PLANT VOGTLE - UNIT 1  
NRC DOCKET 50-424  
OPERATING LICENSE NPF-68  
REPLY TO A NOTICE OF VIOLATION

PLANT VOGTLE - UNIT 1  
NRC DOCKET 50-424  
OPERATING LICENSE NPF-68  
NRC NOTICE OF VIOLATION 88-24-01 AND GPC RESPONSE

VIOLATION 50-424/88-24-01

FIGURE 1

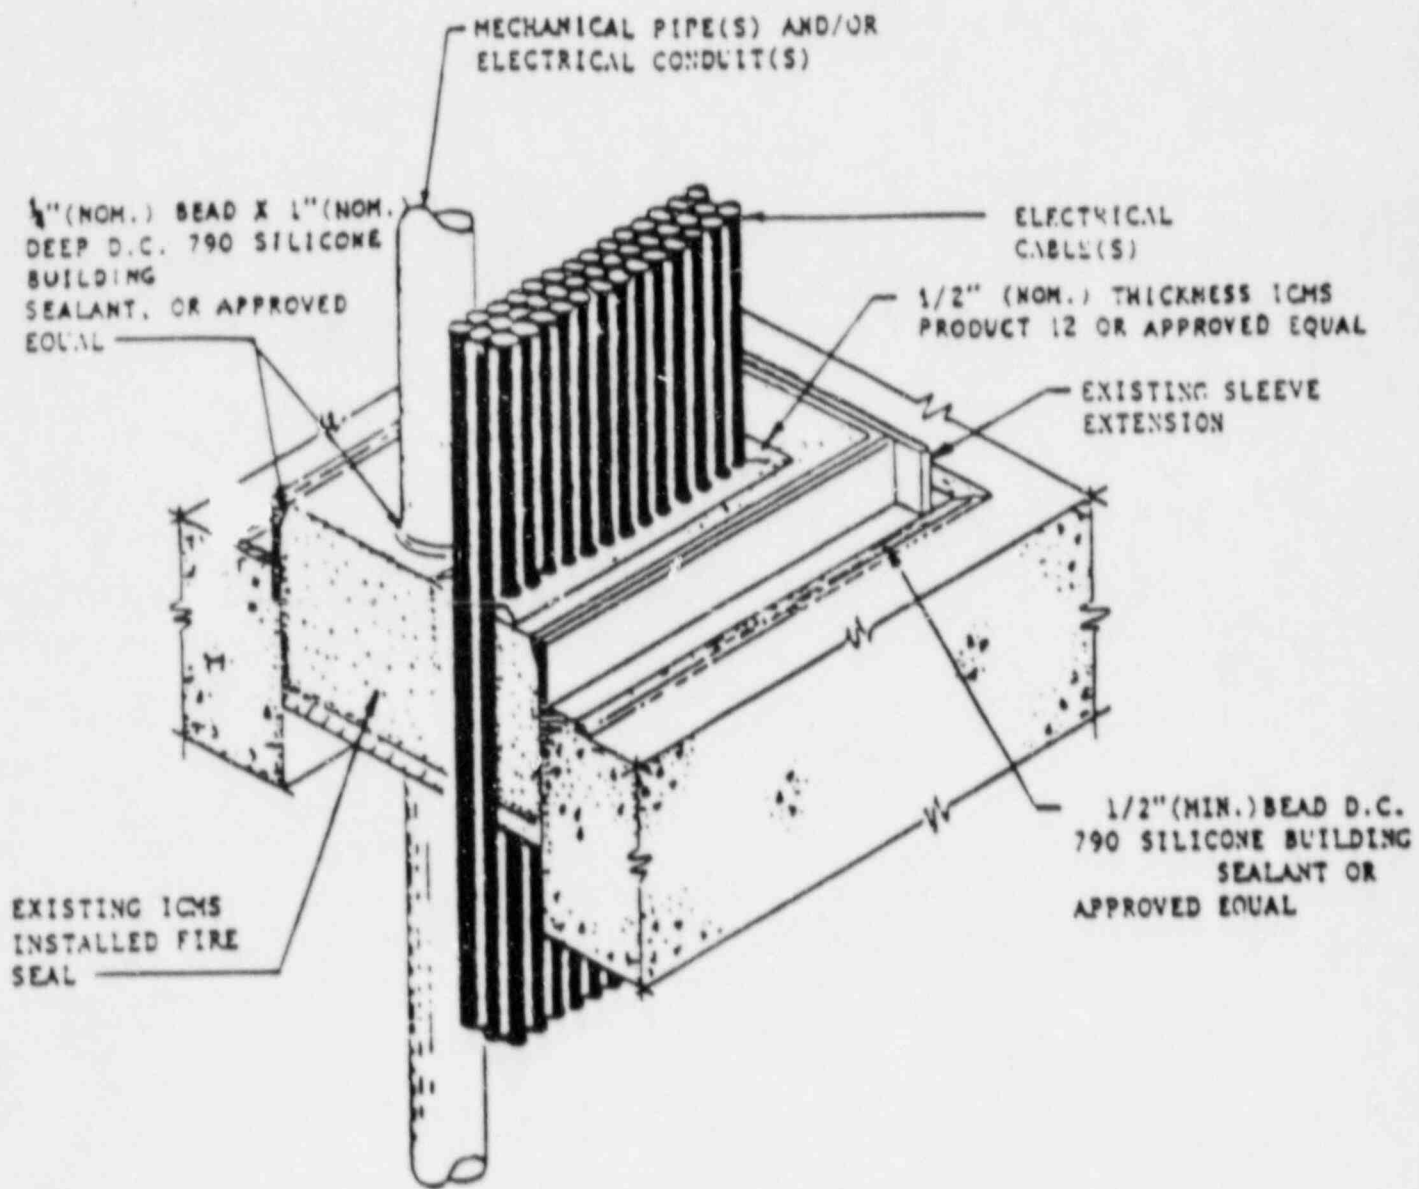
Contrary to the above, as of June 3, 1988, the fire suppression systems were not designed to assure that operation of the systems or manual fire fighting activities would not adversely affect the operability of components required for shutdown or components not involved in the postulated fire. Specifically, because of improperly designed floor penetration seals, a fire in the "B" train cable spreading room could have caused a loss of the auxiliary shutdown panel, the "B" train safe shutdown functions, and due to the water leakage into the control room from fire suppression activities, the "A" train safe shutdown process monitoring could have been rendered inoperable.

The violation occurred due to an inadequate design in that the vendor's qualification test report for the penetration seal detail did not represent typical Upper Cable Spreading Room (UCSR) penetration. The detail that was qualified did not contain a high density cable fill within the penetration whereas the typical UCSR penetration contains a high density cable fill. Further, the architect engineer assumed that the seal weld at the interface of the embedded bottom angle to the top angle would provide an adequate water stop in the event that the UCSR had water on the floor. Testing in Unit 2 (described in detail in the Licensee Event Report (LER) 88-016 dated June 29, 1988) showed that a flowpath existed for water to flow between the top angle and the floor and underneath the embedded angle and into the control room. This has been attributed to the potential deformation of the embedded angle iron caused by the seal welding of the embedded angle to the top angle during installation.

- (1) A full scale prototype test assembly was fabricated on-site to qualify the new penetration seal detail to be used for seals of the type used in the UCSR that would be water-tight. Figure 1 represents a schematic of the current penetration seal configuration in the UCSR. The following methodology was used to determine the materials to be used:

A second full size prototype test assembly which simulates typical foam penetrations in the plant will be water tested. The testing is scheduled for completion on September 30, 1988. As a result, the leaktightness of various types of penetration commodities (i.e., items passing through the penetration) other than the ones shown in Figure 1 will be verified.
